# Service Instruction

(a) No.:	SI 37
(b) Issue / Date	Issue A / 24-01-2024
(c) Title:	Repair of Lindstrand Hot Air Balloons Limited Fuel manifolds
(d) Description:	Supply of the male “Rego” outlet fitting with a 3/78” BSP female thread was discontinued by Service Letter 19. This Service Instruction details alternative parts for repair of ‘Lindstrand’ fuel manifolds.
(e) Applicability:	UK.TC.BA.00001, UK.TC.BA.00002, UK.TC.BA.00003.
(f) Effectivity:	All using ‘Lindstrand’ fuel manifolds

Fig 1: Old Lindstrand Assembly

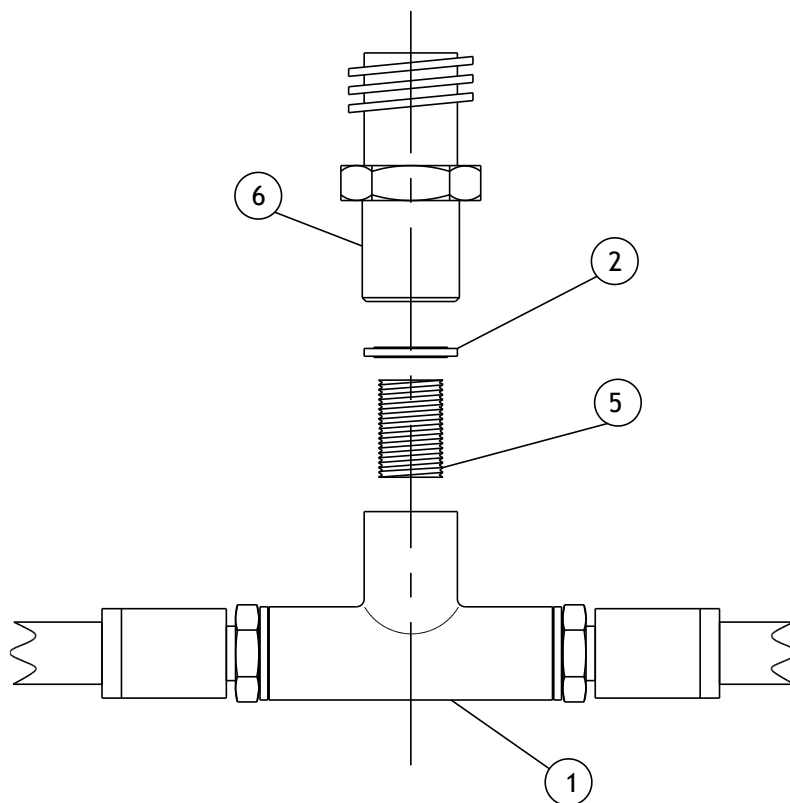
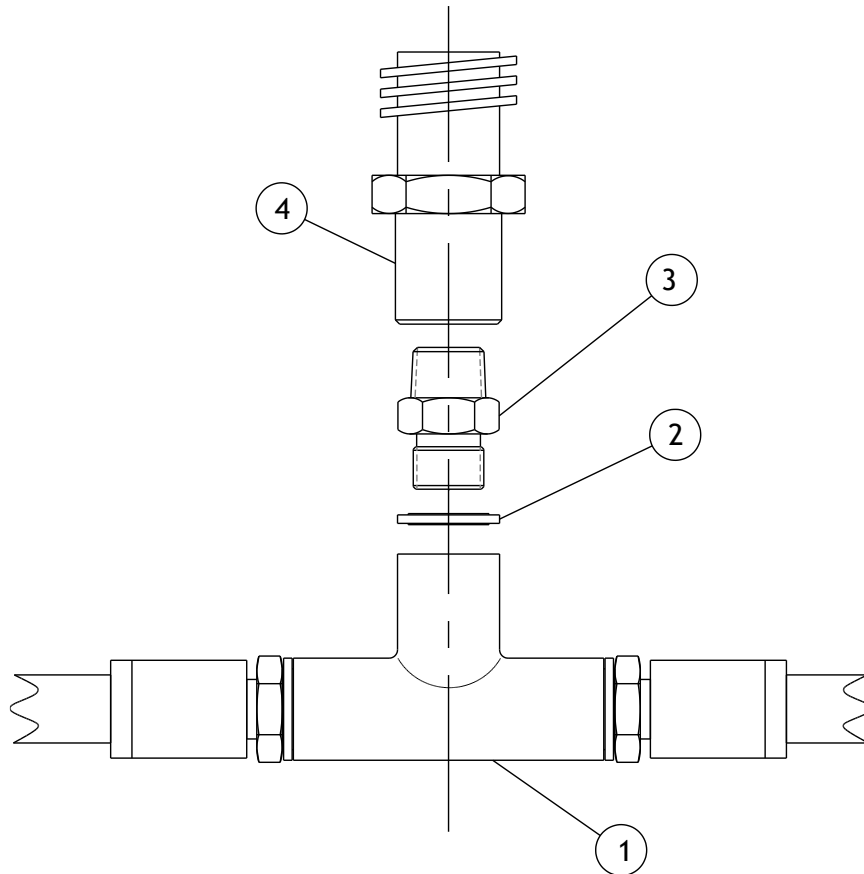
Remove and discard parts 2, 5 and 6 from the manifold assembly. Using a new bonded seal (item 2) re-assemble using parts 3 and 4 and the methods described in the Cameron Balloons Maintenance Manual.

As Above plus PTFE tape. Loctite 572 thread sealing compound or Loctite 270 may be optionally applied to the BSP thread.
